**SUBJECT: Response to Questions Regarding Fuel Conversion**

HEU-LEU Fuel Conversion

The Ohio State University Research Reactor

Responses To Questions

Figure B-1

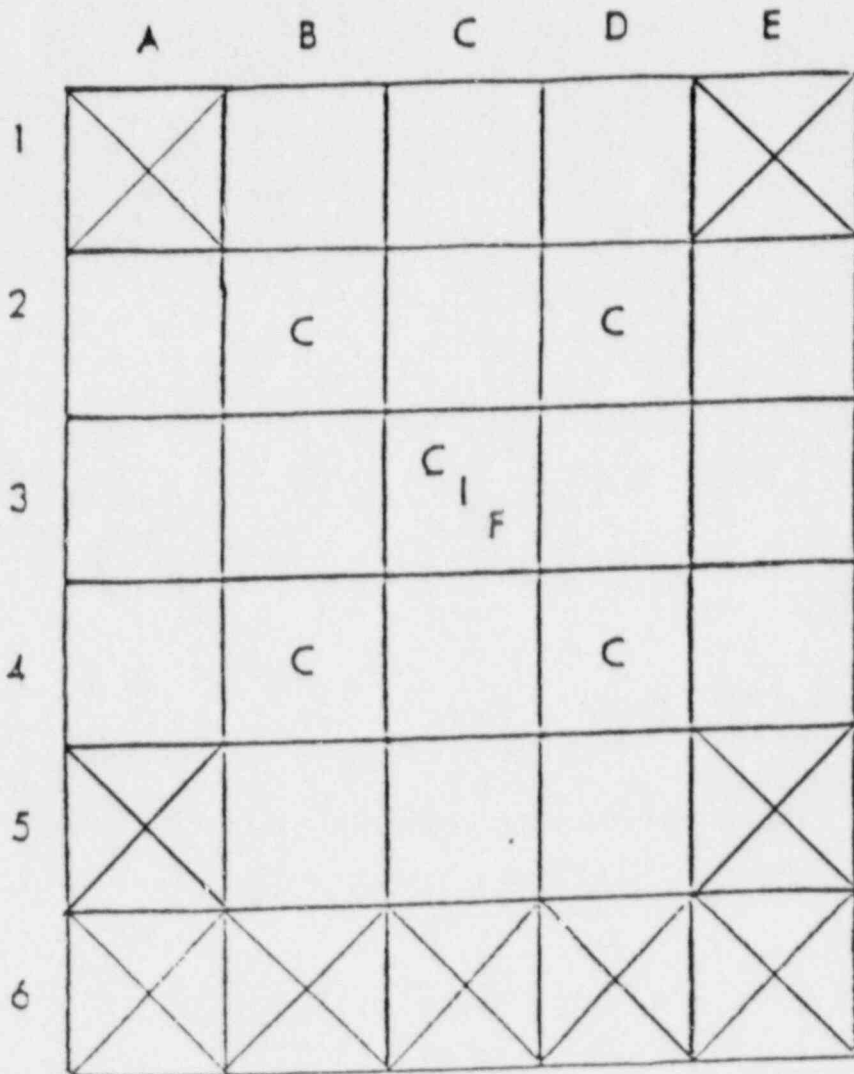
14. Describe and analyze an alternative LEU-fueled OSURR core for operation at 10 kilowatts of steady-state thermal power with an excess reactivity of  $1.5\% \Delta k/k$ .

Figure B-1 shows a sketch of the proposed LEU core having a 1.5%  $\Delta k/k$  excess reactivity. This core has a total of 16 standard fuel elements and 4 control rod fuel elements. The estimated U-235 loading is a nominal 3700 grams.

Proposed LEU Core For The OSURR  
 With An Estimated Excess Reactivity of 1.5%  $\Delta K/K$   
 (X's Denote Plugged Grid Plate Positions)

Figure B-2

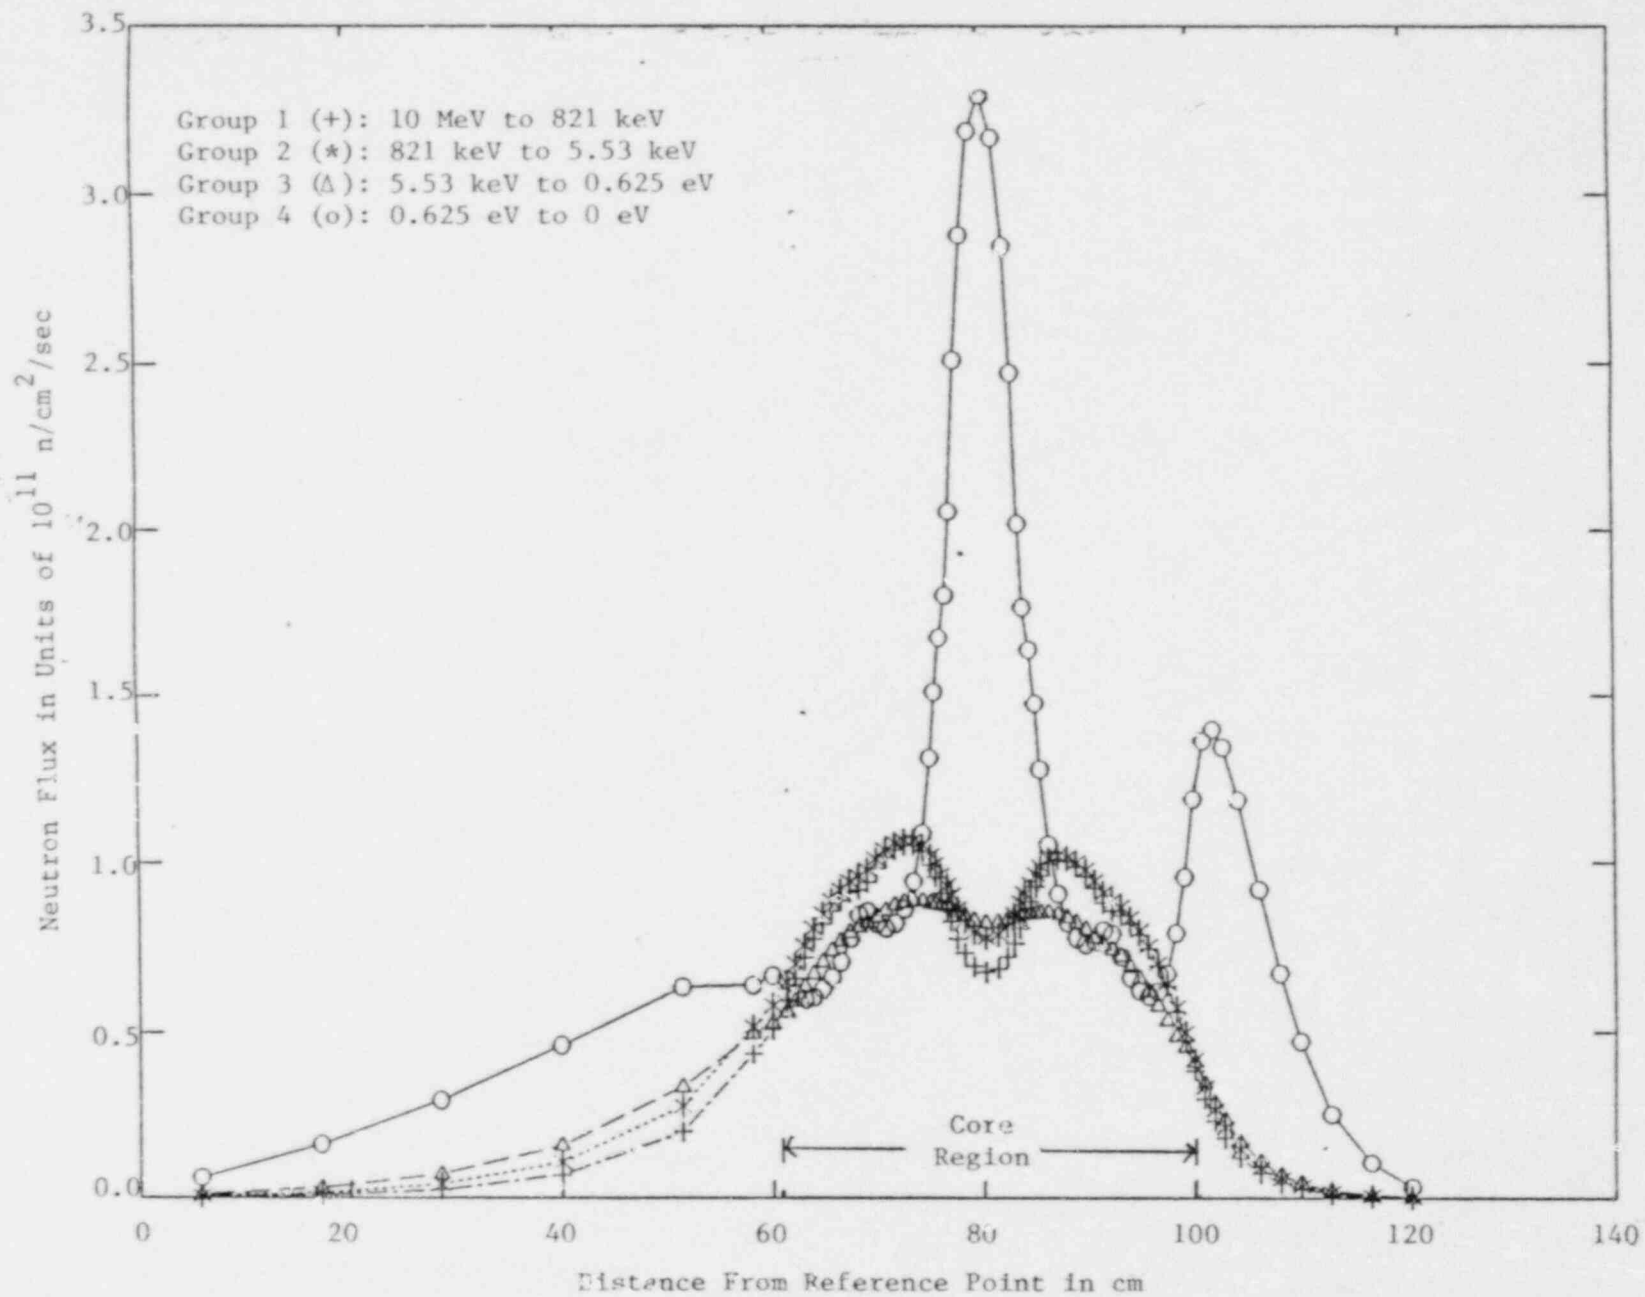
11. What are your calculated maximum, axial, and radial thermal flux peaking factors? What are your calculated maximum, axial, and radial power peaking factors?

For the core discussed in Attachment B to this document, the radial power distribution was estimated based on element-averaged power per fuel plate divided by the core-averaged power per fuel plate. On this basis, the radial power peaking factor is estimated to be 1.285, and the axial power peaking factor is estimated to be 1.275. The total peaking factor is thus 1.64. It is expected that these power peaking factors will be approximately the same as the thermal flux peaking factors. Two-dimensional representations of the neutron flux profiles for various neutron energy groups are shown in Attachment B of this document for the core described therein.

Figures B-2 and B-3 show the calculated neutron flux profiles in the north-south and west-east directions, respectively for four different neutron energy groups. As expected, the thermal neutron flux (Group 4) peaks in the Central Irradiation Facility (CIF) position, and also shows reflector peaking in the graphite thermal columns extensions to the west and south of the core. The fast and epithermal neutron fluxes tend to dip in the CIF position since there is no fuel at this position and neutrons are either absorbed or scattered (thereby losing energy) in the water that partially fills the CIF position.
